PLANNED UNIT DEVELOPMENT**Date: July 21, 2016****DEVELOPMENT NAME**

Volunteers of America

1204 Hillcrest
(West side of Hillcrest Road at the West terminus of Omni
Park Drive)

Planned Unit Development Approval to amend a
previously approved Planned Unit Development to allow
multiple buildings on a single building site along with
shared access and parking.

SITE PLAN

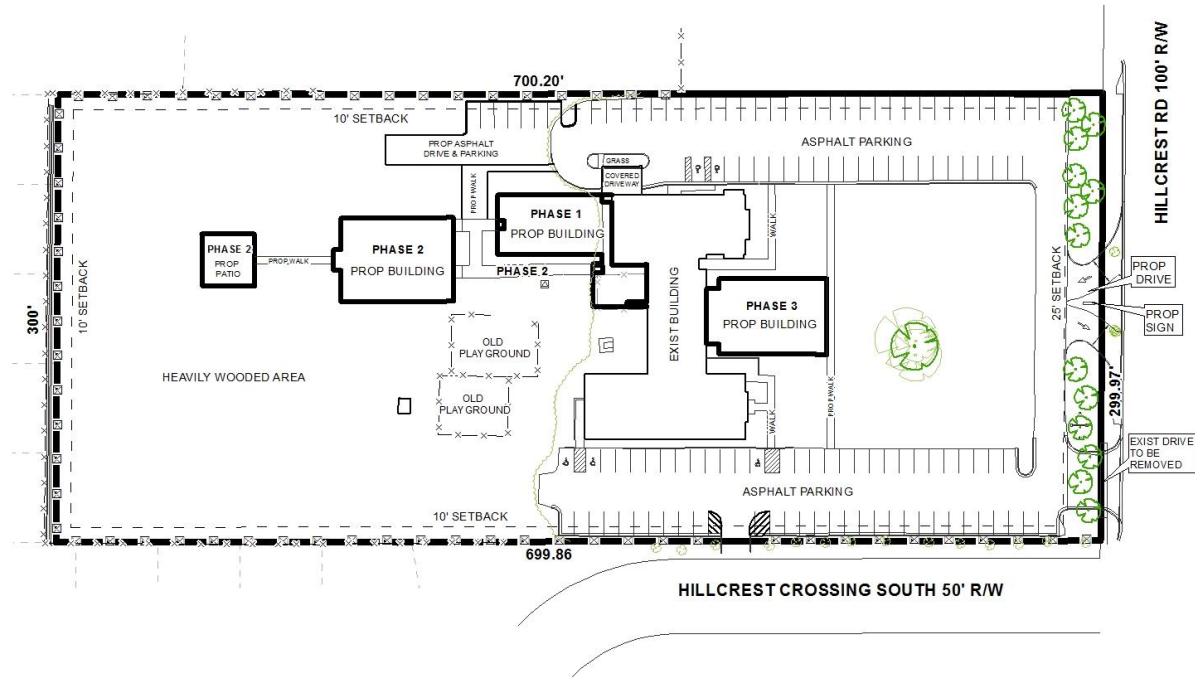
The site is currently developed as a church with associated on-site parking. The applicant proposes to construct three major additions to the site which will be developed in three separate phases. The patio addition will be a part of the second phase. It should be noted; the first and third phase as mentioned in detail in the previous report will remain the same. The size of the patio in square is not depicted on the site. The site plan should be revised to illustrate the total square footage of the patio.

The total amount of proposed tree plantings and landscaping calculations are illustrated on the site plan. However, it appears that the total perimeter tree credit calculations provided cannot be verified or reproduced by staff. Although it appears that full tree and landscaping compliance is possible, staff cannot accurately determine the total number of tree credits based on the plan submitted. The site plan submitted for Land Disturbance must clearly identify and depict the

trees claimed for tree credits. The site plan should be in full compliance with Section 64-4.E of the Zoning Ordinance.

It should be noted, the metal shed on skids was illustrated as "to be removed" on the previous site plan, however the new site plan does not reflect those changes. If the shed is going to be removed the site plan should be revised to depict it.

- 1) the submission of a Planning Approval application;
- 2) revision of the site plan to depict the metal shed on skids with a note to be removed if it is indeed going to be removed; and
- 3) revision of the site plan to depict the square footage of the concrete patio.

Planned Unit Development: Based upon the preceding, this application is recommended for Holdover until the August 18, 2016 meeting, with revisions due by Tuesday July 26, 2016 to address the following:
